## REQUEST

Current Zoning: R-3 (single family residential)  
Proposed Zoning: R-12MF(CD) (multi-family residential, conditional)

The petition proposes to allow a multi-family residential development on a vacant parcel of land in southwest Charlotte, northeast of Rivergate.

## STAFF RECOMMENDATION

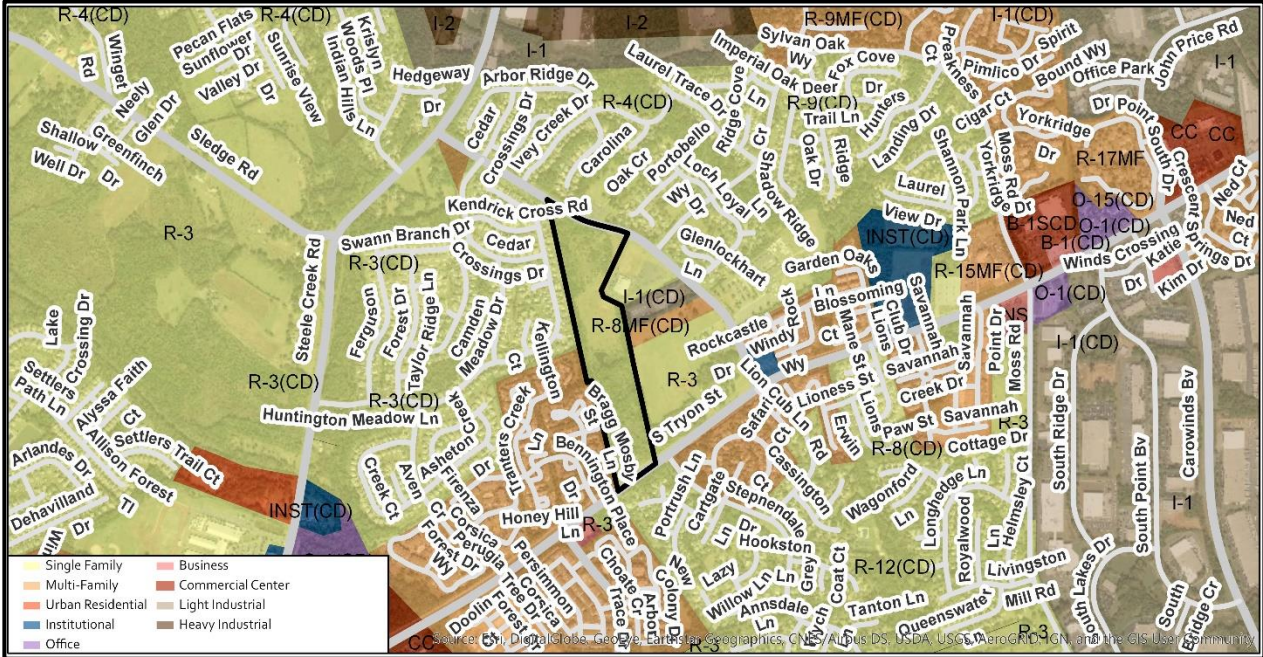
- A 50-foot Class C buffer with 5-foot decorative fence along the portion the western property line abutting single family detached homes zoned R-3(CD). A separate note indicates only 37.5-foot buffer; needs clarification.

1. Reduce density of proposal to better conform to the recommendations of the area plan.
2. Consider reducing building masses of buildings 6, 7, & 8 to better transition to adjacent single family uses.
3. Increase fence height from 5 feet to 6 feet along adjacent single family property lines, and clarify fence type to ensure it provides adequate screening.

4. Under Site Data remove "Min. Building Separation: 10' Per Ordinance" from the site plan.
5. Label setbacks along Erwin Road and Public Road A.
6. Confirm if the area adjacent to proposed Building 3 is a dumpster enclosure/refuse area. If so, label on the site plan.
7. Remove Monument Sign label and proposed location from the site plan.
8. Petitioner proposes a 50-foot Class C buffer along the western property line. Open Space and Amenities Note VII.3 proposes a "minimum 37.5-foot Class C buffer" in this location. Petitioner should clarify intent to have ability to reduce buffer by 25% with wall or fence per ordinance and modify labelling and development note to reflect consistency.
